HOMARC COMMERCIAL DEVELOPMENT

FINAL ENVIRONMENTAL IMPACT STATEMENT 152 NY STATE ROUTE 94 SOUTH

**December 2014
Revised: March 2015**

GREENPLAN COMMENTS:

FIGURE 3-9

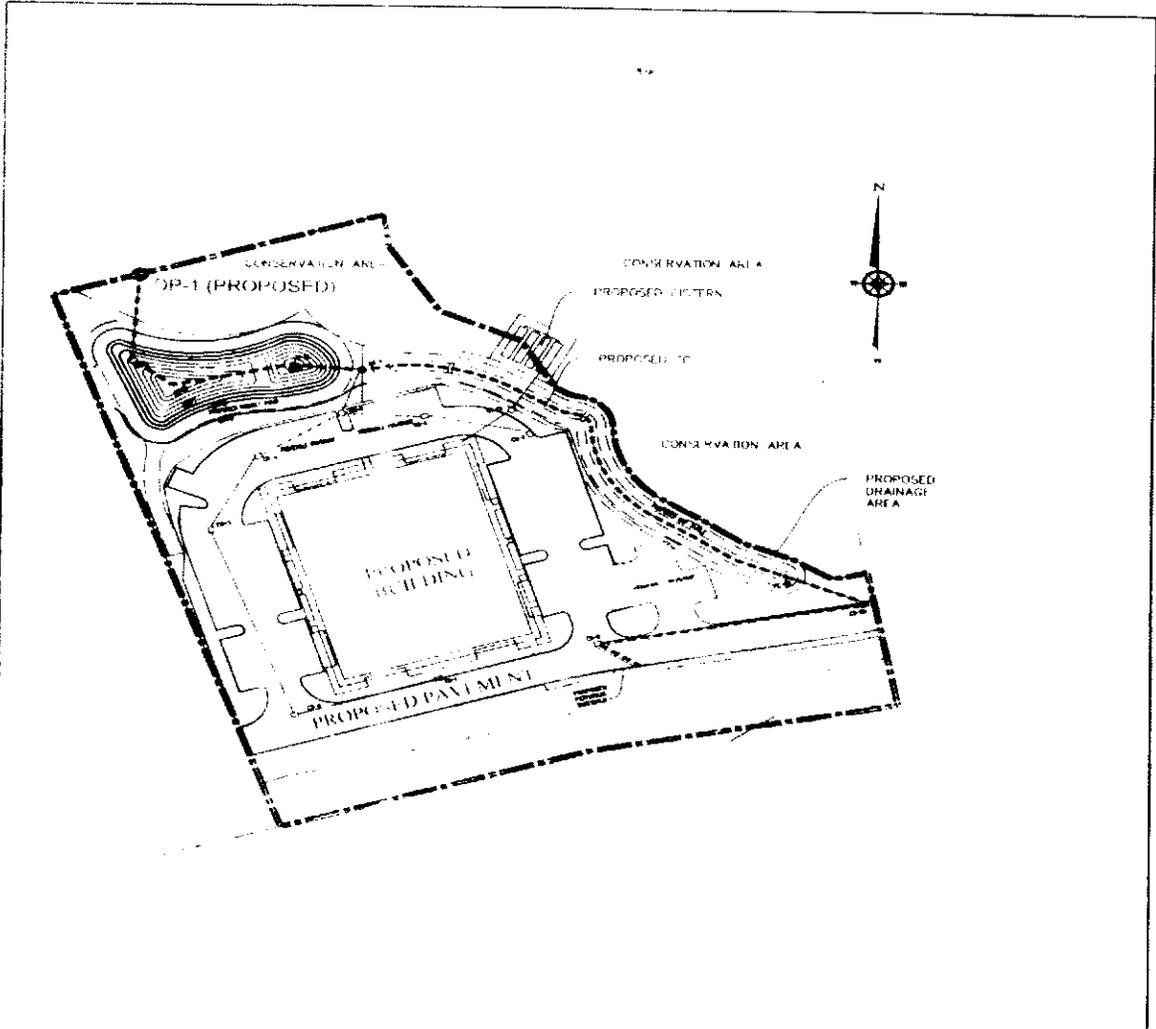
51. DEIS Page 3-17: The first paragraph states that the runoff from the remaining portions of the site will not be affected by the proposed project. Development is proposed outside of the one drainage area that is analyzed. Applicant shall update the existing drainage area map (Figure 3-9) to include all portions of the site that will be developed. Applicant should coordinate Figure 3-9 in the DEIS with Figure 3 provided in Appendix C.

Response: Figure 3-9 has been updated to include all portions of the site that will be developed.
